Access Compliance Report

Public Rights-of-Way

(Curb Ramps)

Intersection ID: 14278	Main Street: ROMARE_BEARDEN_DR	Cross Street: FARMER_ST	Location: W
ADA ID: 44E53FBE7456	Ramp Type: MedianPerp	Initial Pass/Fail: Fail	Overall Compliance: No
Severity Score: 1.25			
Codes/Mitigation Info/Possible Solution		Field Measurements/Component Compliance

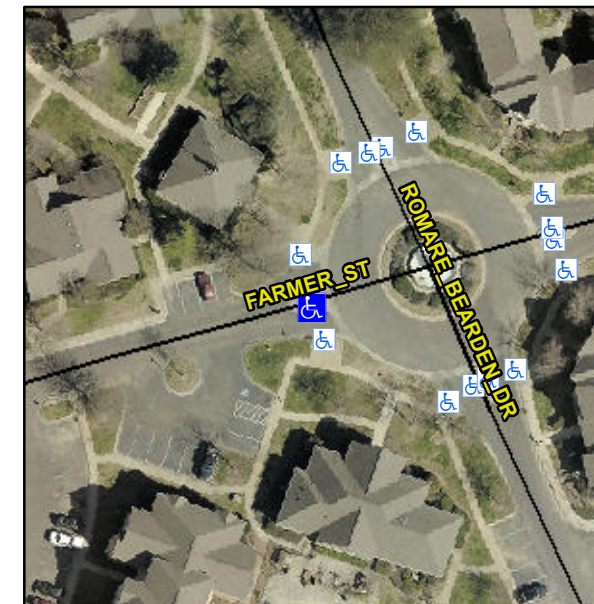
Not Found, R304.5.3

Compliance	Description	Data	Compliance	Description	Data
N/A	Ramp Length (in)	43.0	Yes	Ramp Slope (%)	6.4
Yes	Ramp Width (in)	58.0	No	Ramp XSlope (%)	3.0
N/A	Flare Type LT	N/A	N/A	Flare Type RT	N/A
N/A	Flare Slope LT (%)	N/A	N/A	Flare Slope RT (%)	N/A
N/A	Flare Traversable LT?	N/A	N/A	Flare Traversable RT?	N/A
N/A	Landing Length (in)	N/A	N/A	DWS Provided?	N/A
N/A	Landing Width (in)	N/A	N/A	DWS Contrast?	N/A
N/A	Landing Slope (%)	N/A	N/A	DWS Length (in)	N/A
N/A	Landing X Slope (%)	N/A	N/A	DWS Full Width?	N/A
N/A	Landing Curb? (Y/N)	N/A	N/A	DWS Offset (in)	N/A
N/A	Shared Landing?	N/A			
N/A	Gutter Ponding?	N/A	N/A	Gutter Slope (%)	N/A
N/A	Gutter Lip Ht (in)	N/A	N/A	Gutter X Slope (%)	N/A
N/A	Painted X Walk1?	No	N/A	Painted X Walk2?	N/A
	X Walk 1 Direction	To S		X Walk 2 Direction	N/A
N/A	X Walk 1 Width (in)	N/A	N/A	X Walk 2 Width (in)	N/A
	X Walk 1 Slope (%)	0.6		X Walk 2 Slope (%)	N/A
	X Walk 1 X Slope (%)	0.5		X Walk 2 X Slope (%)	N/A

Remove & Replace Entire Ramp.
